RESOLUTION NO. R-362-07

RESOLUTION AUTHORIZING THE ERECTION, CONSTRUCTION AND OPERATION OF THE COMMUNITY ACTION AGENCY (CAA) ARCOLA REGIONAL CHILDCARE CENTER ON A 2.17-ACRE PORTION OF COUNTY OWNED PROPERTY LOCATED AT 799 NW 81ST STREET, IN COMPLIANCE WITH SECTION 33-303 OF THE CODE OF MIAMI-DADE COUNTY

Subject: Governmental Facilities Hearing for CAA Arcola Childcare Center
GF06-07

Subject: Governmental Facilities Hearing for CAA Arcola Childcare Center
GF06-07

PROPOSED
CAA SITE PLAN

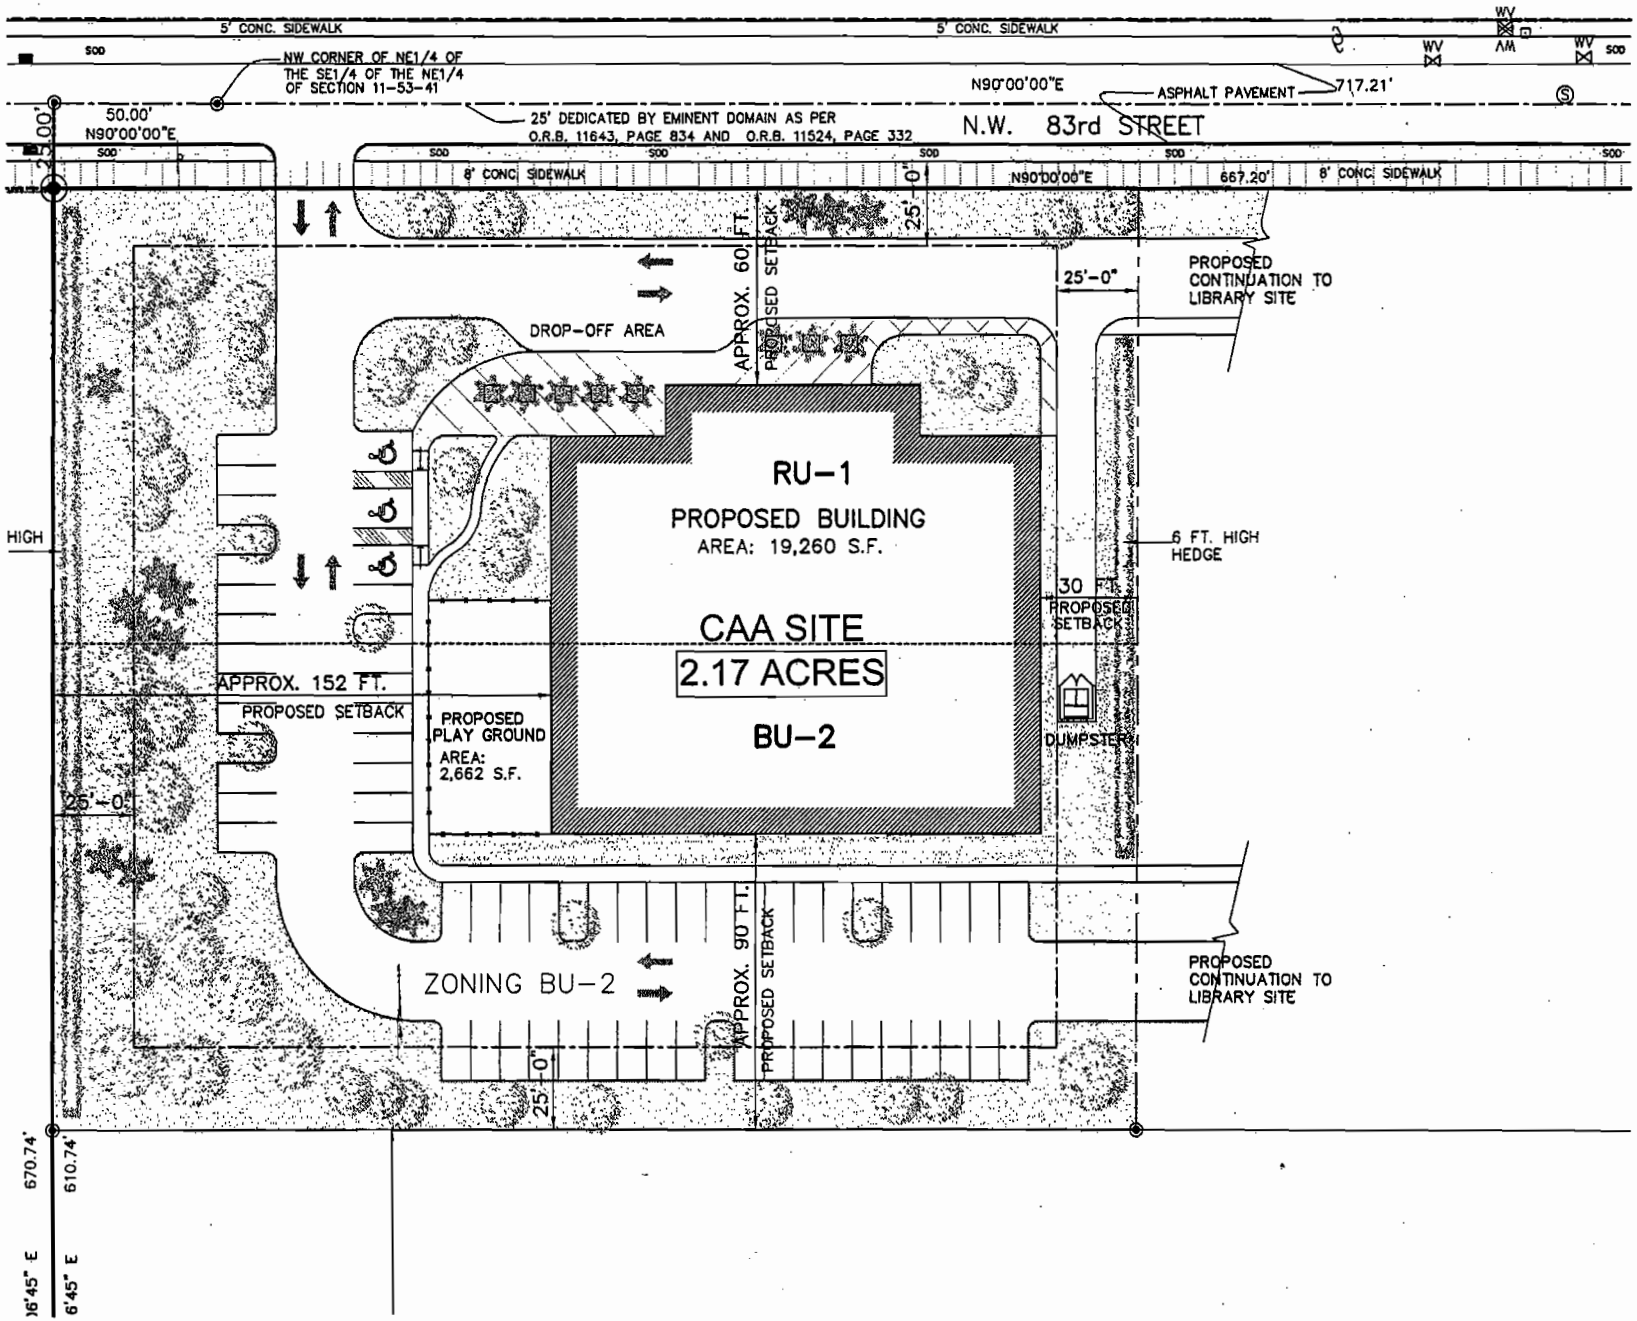
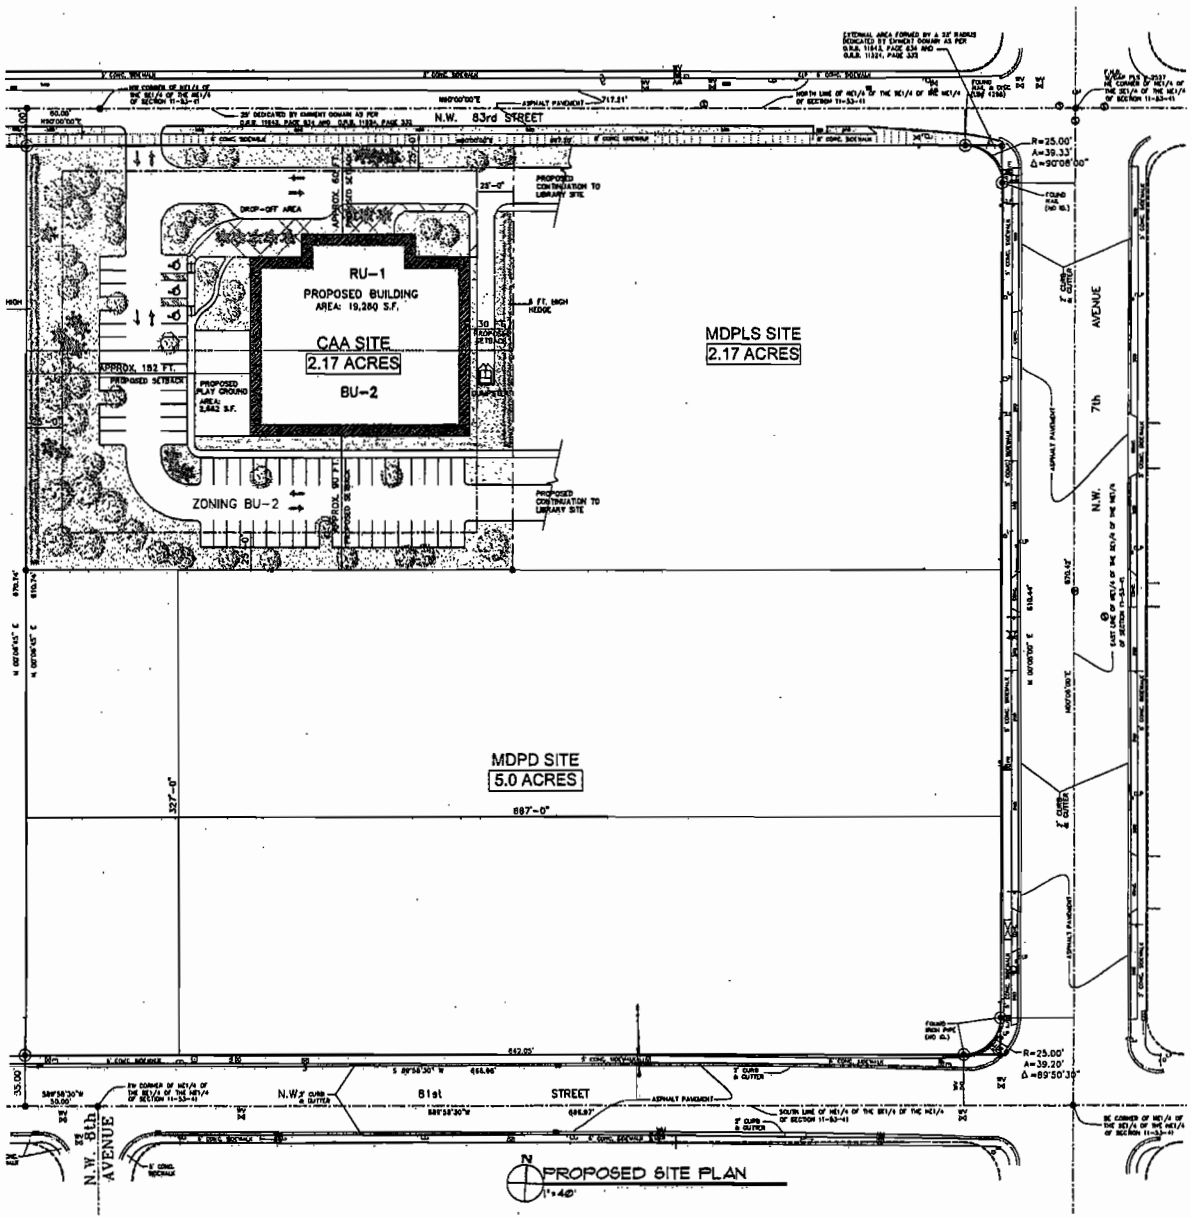
The **Department of Planning and Zoning** recommends approval with conditions of the request to develop a childcare facility. The facility is deemed consistent with the Miami –Dade County

Comprehensive Development Master Plan (CDMP) that permits childcare uses in all land use designations when compatible with the surrounding area. Staff is of the opinion that the facility is well landscaped and has an architectural scale that is in harmony with the surrounding residential community, therefore staff also finds the childcare facility to be compatible with the surrounding zoning districts.

1. That a plot plan be submitted to and meet the approval of the Director; said plan to include among other things but not limited thereto, location of building or buildings, type and location of signs, light standards, parking areas, exits and entrances, drainage, walls, landscaping, etc.

2. That the applicant submit to the Department of Planning and Zoning for its review and approval at the time of building permit, a landscaping plan which indicates the type of plant material and size to be installed prior to final construction sign off.

The **Office of ADA Coordination** has reviewed the application and approves based on the following conditions:

2. An accessible route will be provided to nearest bus stop.
3. Conceptually, there are no ADA site issues, however, we will carefully review final site construction plans for the following:

4. Accessible routes including slopes and cross slopes.
5. Tactile warnings along accessible routes at vehicular crossings.
6. Accessible parking space locations, slopes, dimensions, striping and signage.

7. Final design of vehicular drop off area including width of vehicle lane, access aisle, path of travel between drop-off vehicle and front door of facility and location of bollards (if any).

8. Play equipment must comply with design guidelines published in July 23, 2004 Federal Register.
9. This office will also review and approve building construction plans for ADA compliance prior to issuance of Miami-Dade Building Permit.

Water:
Connect to an existing twenty (20)-in. water main in NW 7th Avenue and NW 81 Street and extend a twelve (12)-in water main westerly in NW 81st Street to the SW corner of the property, interconnecting to an existing six (6)-in water main at that location. Any public water main extension within the property shall be twelve (12)-in water main minimum in diameter. If two or more fire hydrants are to be connected to a public water main extension within the property, then the water system shall be looped with two public water main extensions within the property, then the water system shall be looped with two (2) P.O.C. Separate connections for fire lines and fire hydrants are required.

Sewer:
Connect to any of the existing eight (8)-in. gravity sewer in NW 83rd Street and/or NW 7th Avenue. If unity of title does not apply any gravity sewer within the property shall be public and eight (8)-in. minimum in diameter.

All stormwater shall be retained on-site utilizing properly designed seepage or infiltration drainage structures. Drainage must e provided for the 5-year/1-day storm event with full on-site retention of the 25-year/3-day storm.
